Revisions to Electric Reliability Organization Definition of Bulk Electric System and Rules of Procedure; Proposed Rule

[Docket Nos. RM12-6-000 and RM12-7-000]

Revisions to Electric Reliability Organization Definition of Bulk Electric System and Rules of Procedure**AGENCY:** Federal Energy Regulatory Commission, DOE.**ACTION:** Notice of proposed rulemaking.

Figure 1

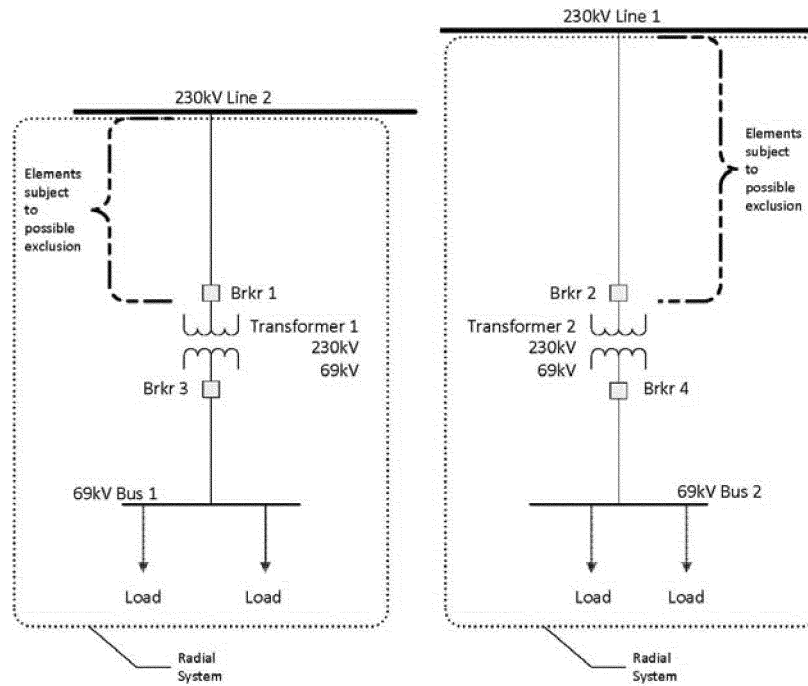
79. Figure 1 below depicts facilities configurations in which all of the 230 kV and 69 kV transmission elements emanate from a single point of connection of 100 kV or higher. The Commission seeks comment on whether each of the radial systems shown in figure 1, the 230 kV elements above each transformer to the point of connection to each 230 kV line, respectively, are excluded from the bulk electric system pursuant to exclusion E1.

Figure 2

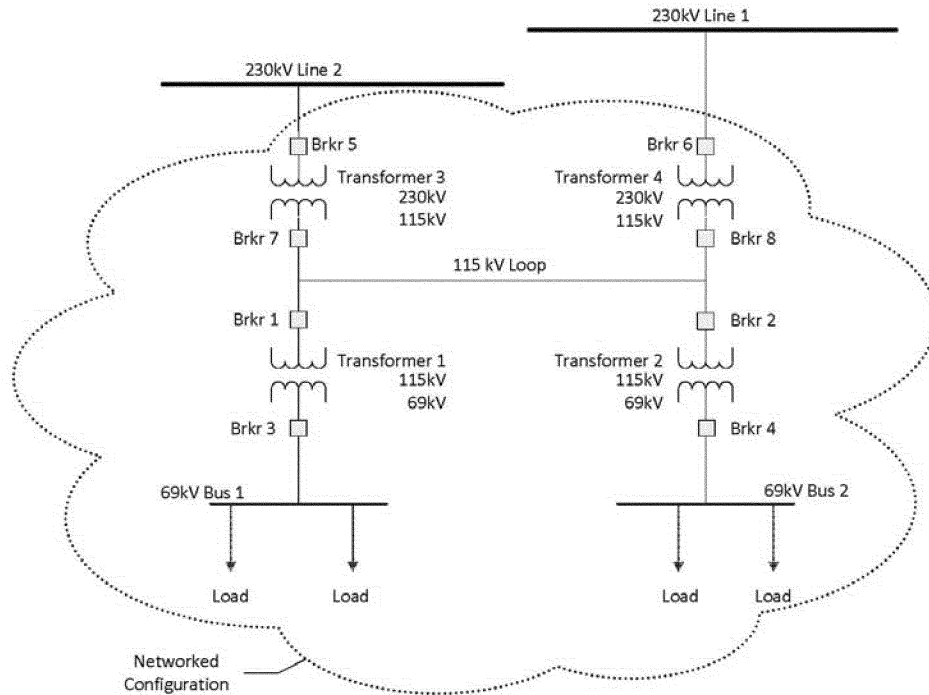
80. Another scenario shown in figure 2 below depicts a configuration containing a 115 kV loop, with the configuration emanating from two points of connection of 100 kV or higher. We seek comment whether, in

shown in figure 2 more appropriately analyzed pursuant to the "local network" exclusion E3 and, if so, what if any elements operated at or above 100 kV would be excluded pursuant to exclusion E3?

Figure 3

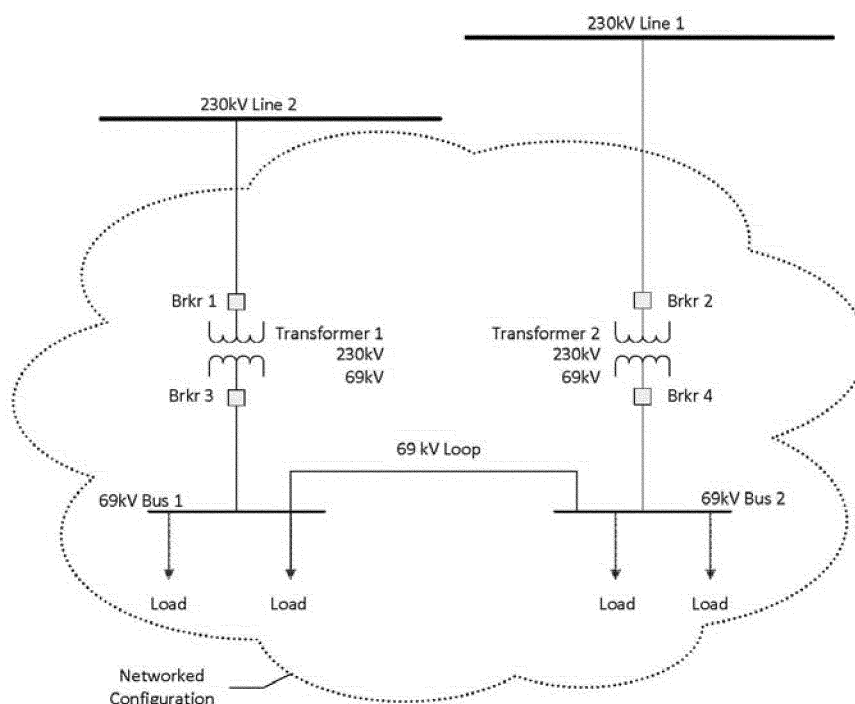
configuration remains contiguous through elements that are operated below 100 kV. For example, figure 3 below depicts a configuration with two points of connection of 100 kV or higher that are contiguous through a 69 kV loop. We seek comment on how to evaluate the configuration in figure 3 vis-à-vis the radial system definition and whether it is appropriate to examine the elements below 100 kV to

determine if the configuration meets the exclusion E1 definition for radial systems. In other words, does figure 3 depict a system emanating from two points of connection at 230 kV and, therefore, the 230 kV elements above the transformers to the points of connection to the two 230 kV lines would not be eligible for the exclusion E1 notwithstanding the connection below 100 kV?

Figure 4
69 kV Networked Configuration with Normally Open Switch

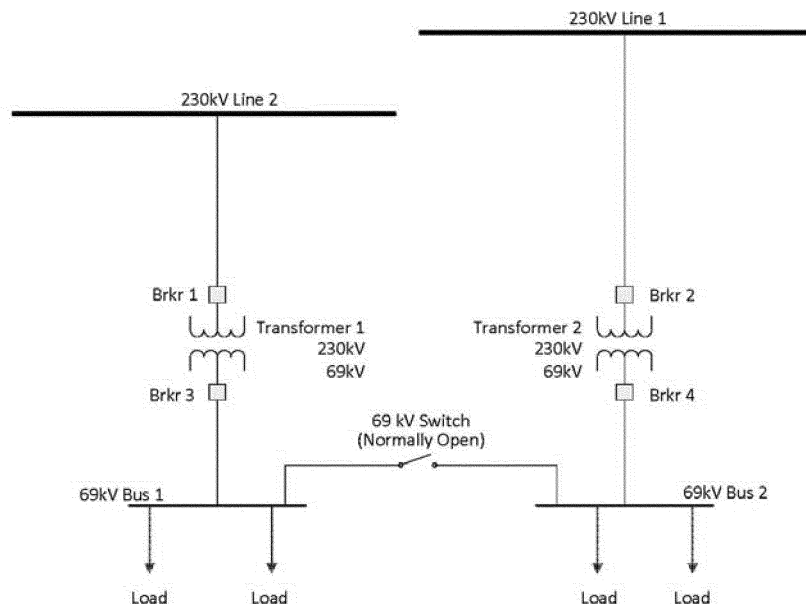
86. Figure 4 below illustrates a configuration with a normally open switch.

87. NERC states that “a normally open switch” will be identified in documents such as prints or one-line diagrams and that “[t]he concept and usage of the ‘normally open switch’ in such configuration is well understood in the electric utility industry.”¹⁰⁵ We seek comment on NERC’s characterization and whether the phrase “normally open” is subject to interpretation or misunderstanding, or whether a “normally open” configuration is potentially difficult to oversee. Further, we seek comment on the need of transmission operators or other functional entities to study the system impacts of the closing of a “normally open” switch, or to take other steps to ensure awareness of the impacts of the loop that is created by the closing of the

Figure 5

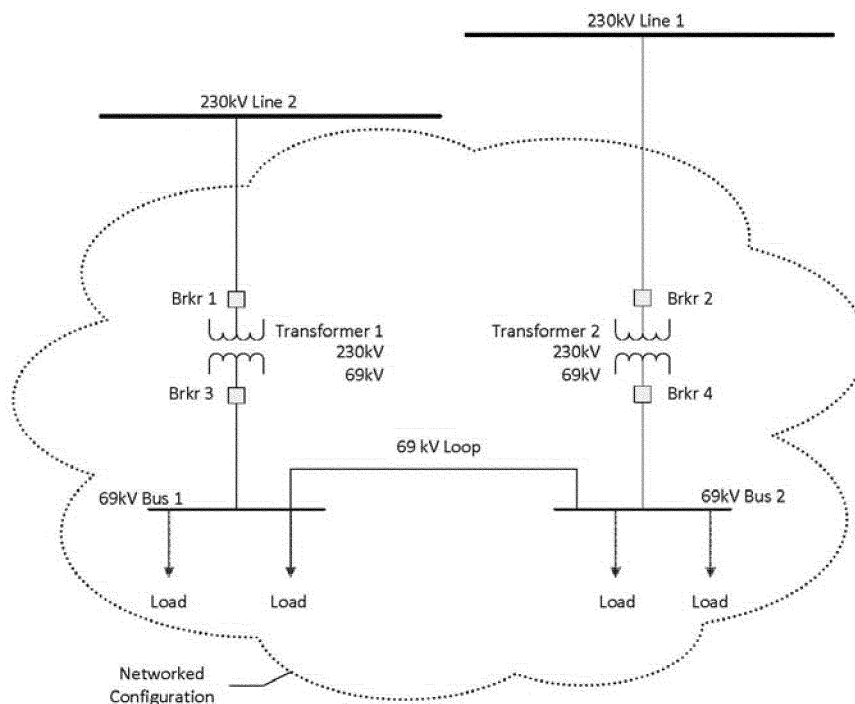
95. As stated above, exclusion E3 defines local networks as “[a] group of contiguous transmission Elements operated at or above 100 kV but less than 300 kV that distribute power to Load rather than transfer bulk-power across the interconnected system.” While the local network exclusion applies to contiguous transmission elements operating at a minimum of 100 kV, it is unclear how the exclusion applies to a looped lower voltage system. For example, figure 5 depicts a 69 kV looped system emanating from two points of connection at 100 kV or higher.

The configuration in figure 5 depicts a group of elements that are contiguous through a 69 kV loop. We seek comment whether the configuration in figure 5
